INDEPENDENT SEPP 65 PEER REVIEW

500-520 PACIFIC HIGHWAY, ST LEONARDS

Final Report

Prepared for Lane Cove Council

Figure 8 Future setback relationship between 69 Christie Street and 500-520 Pacific Highway (Source: Urbis Amended SEE, Oct 17)

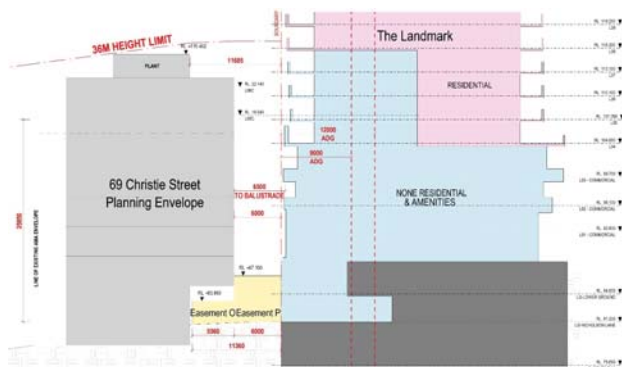
Issue - Privacy	Relevant Commentary by Architectus	Studio GL Review and Comments
	South The building separation achieved is 11.2 metres. The DCP requires 12 metres in this location (Lane Cove DCP, Part D, Section 4.4 Separation). The ADG requires 12 metres (up to the fourth storey), 18 metres (5-8 storeys) and 24 metres for the ninth storey and above. Architectus considers the building separation appropriate in this instance due to the following factors: • Communal open space is provided at ground level and level 1 along the southern portion of the floorplate, • Commercial uses are provided at level 2 to level 7 and occupy the southern portion of the floorplate, • Architectus considers that given the outlook and street address of 69 Christie Street, it is likely that orientation would be toward the street and significant views to the south. It is therefore likely that primary outlook would not be toward the subject site. Furthermore, the DCP provides site specific controls for a building on this site. It is considered that this has been prepared in context of the site's surrounds.	South Studio GL notes that the proposed development is located between 0.2m and 2m off the southern boundary of the site up to the maximum building height and that the 2m balcony articulation zone is provided between the southern boundary of the site and the building. We do not agree with the SEE that states that “the upper level residential balcony setbacks vary from 1-5 m from the southern boundary” as the balconies shown on the drawings are closer to the boundary than 1m. The property to the south of the site, 69 Christie Street, is burdened by easements, predominantly for access. The survey plan does not indicate that these easements are also easements for light or ventilation, nor is it a public or private laneway (although it is referred to as Nicholson Lane on the architect's drawings and in the assessment by Architectus, and is referred to as Christie Walkway within the St Leonards Public Domain Masterplan 2014.) If it is a laneway the Lane Cove DCP requires that the proposed development should be setback 6m above 2 storeys. If it is a rear setback the Lane Cove DCP would normally require 6m however this setback is not required in special areas like this one and we agree that the setbacks comply with the site-specific controls under the Lane Cove DCP2010. We also agree with Architectus that the building separation between the existing building on 69 Christie Street and the proposed development is 11.2 metres and that this is acceptable. We agree that as the site at 69 Christie Street is zoned B3 Commercial Core and as residential development is not permitted, SEPP 65 and the accompanying ADG are not matters for consideration in the assessment of a future commercial building on that site. For the lower levels of this building the relationship between the proposed development and 69 Christie Street is one between commercial uses and so is not directly relevant to a SEPP 65 Assessment.

Issue - Privacy	Relevant Commentary by Architectus	Studio GL Review and Comments
<i>Principle 2: Built Form and Scale Good design achieves a scale, bulk and height appropriate to the existing or desired future character of the street and surrounding buildings. Appropriate built form defines the public domain, contributes to the character of streetscapes and parks, including their views and vistas, and provides internal amenity and outlook.</i> Continued below...	Principle 2: Built Form and Scale The proposal achieves the required 24 metre separation with 472-486 Pacific Highway for levels 9 and above, between habitable rooms. The building separation to the south is supportable given the proposed commercial uses along the southern elevation, between levels 2 to 7. Further, the building separation to the west will not strictly comply with potential future development on the adjacent property, however it does provide sufficient setback to achieve the minimum tower separation required under the precinct specific DCP controls. 2B Building Envelopes The ground level setback of the proposal complies with the DCP requirement of a 4m setback from the Pacific Highway, Friedlander Place and 0m minimum from the western and southern boundary. The DCP prescribes that the non-residential podium, Levels 1 – 3, must comply with a 0m minimum setback from all boundaries. The proposal achieves this setback control. While the podium is compliant at all podium levels, the tower component of the proposal exceeds setback controls, predominantly along the Pacific Highway boundary. Along the Pacific Highway boundary, the tower is to be set back 4m. Sections of level 4 have close to 0m setback, and levels 5 to 43 frequently protrude into the 4m setback zone by up to 1.2m. In this instance, level 4 balconies are acceptable as they occupy the roof of level 3 of the podium. 2G Street Setbacks The podium component of the proposal complies with all relevant setback controls. However, the residential tower component does not strictly comply with the 4m setback from Pacific Highway boundary. 2H Side and Rear Setbacks Side and rear setbacks are compliant with DCP controls. The DCP requires a 4m ground level setback to Friedlander Place and 0m west and south setback for all podium levels.	As previously noted Studio GL agrees that the separation distance between the proposal and 472-486 Pacific Highway complies with the ADG and is acceptable. The building separation to the west can comply with the precinct specific site controls for 12m between towers, however as previously commented careful orientation of future development on the neighboring site would be required to achieve acceptable impacts. Studio GL agrees that setbacks to the ground level and non-residential podium levels (1-3) are appropriate for the north, east and west. We also agree that the slight protrusion of balconies, into the 4m DCP control setback, on the Pacific Highway, should not have significant privacy impacts on the proposed dwellings or adjacent sites. Additionally, extending the level 4 balconies to the site boundary along the Pacific Highway should not have significant privacy impacts. However, while not strictly required from an ADG privacy perspective, Studio GL recommends that an increased setback to the commercial levels on the southern side is considered during design refinement (possibly by removing balconies to commercial floors). The 3 to 4 storey podium facing Pacific Highway becomes 6 storeys facing 'Nicholson Lane' due to the level change, which could give an oppressive character to the potential future laneway if 69 Christie Street is developed.

Figure 9 Podium section (Source: AplusDG)

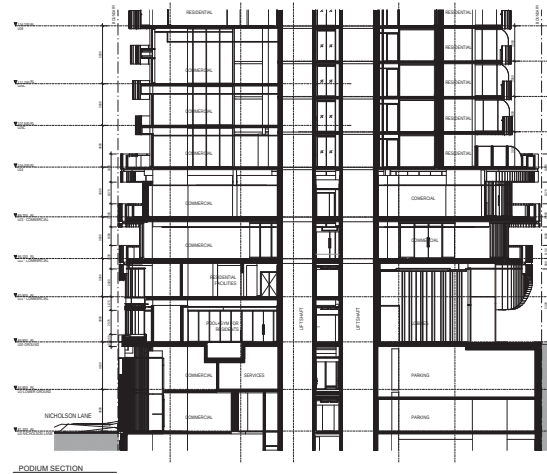
Issue - Privacy	Relevant Commentary by Architectus	Studio GL Review and Comments
<i>Principle 6: Amenity - Good design positively influences internal and external amenity for residents and neighbours. Achieving good amenity contributes to positive living environments and resident well being.</i> <i>Good amenity combines appropriate room dimensions and shapes, access to sunlight, natural ventilation, outlook, visual and acoustic privacy, storage, indoor and outdoor space, efficient layouts and service areas, and ease of access for all age groups and degrees of mobility.</i>	Principle 6: Amenity ‘Generally, the proposal produces apartments with good outlook’ 3F Visual Privacy The podium and residential tower component are adequately separated to achieve visual privacy for the western, northern, and eastern elevations (non-trafficable balconies) of the proposal. As discussed above at Objective 2F, the proposed commercial uses between level 2 – 7 along the southern elevation of the building will provide adequate privacy between the proposed and the future potential development to 69 Christie Street. The balustrade design is supported as it achieves high aesthetic outcomes and resident privacy. In addition, Architectus is satisfied that adequate visual privacy is provided between apartment balconies, achieved by appropriately designed balcony party walls.	Studio GL agrees that generally the proposal produces apartments with good outlook and the outlook of lower level south facing apartments (which start at level 8) should not be compromised by a future development up to the maximum building height on 69 Christie Street. As noted above, Studio GL agrees that adequate separation distances are achieved to the north, east and west for the podium component and for the tower element. We also agree that incorporating commercial uses between levels 2-7 along the southern boundary has removed the conflict between commercial and residential uses to the south. While the relationship between commercial uses is not strictly relevant to apartment design, Studio GL consider that the separation distance to the south between commercial uses could be improved (possibly by removing balconies to commercial floors). As the proposed development has little or no setback to the south the current arrangement could result in a narrow 6m wide "laneway" above the ground floor when the 69 Christie Street site is redeveloped (as shown in Figure 7). The redevelopment of 69 Christie Street will be important for the long term success of this area as it could activate the walkway/ laneway and support retail uses on the lower ground floor of the proposal as recommended within the St Leonard's Public Domain Masterplan (2014). We note that the future setback relationship (shown in Figure 8) is incorrect as it shows 4 and not 3 commercial floors between level 4-8. As shown in the architects section (Figure 9) the south facing commercial floor space has a different floor to floor height than the north facing residential units, and has sections of balustrade extending across the façade at varying heights, reducing internal light levels and views from the south facing spaces. Studio GL do not consider the design and layout of commercial spaces on these levels to be well considered and suggests that these could be improved during detailed design.

Studio GL also agrees that the proposed development complies with the current DCP and that the southern interface is acceptable when assessing impacts for the current building at 69 Christie Street. While not directly related to the issues addressed in this report, Studio GL considers that the setback and design of the commercial levels on the southern interface could be improved during detailed design refinement.
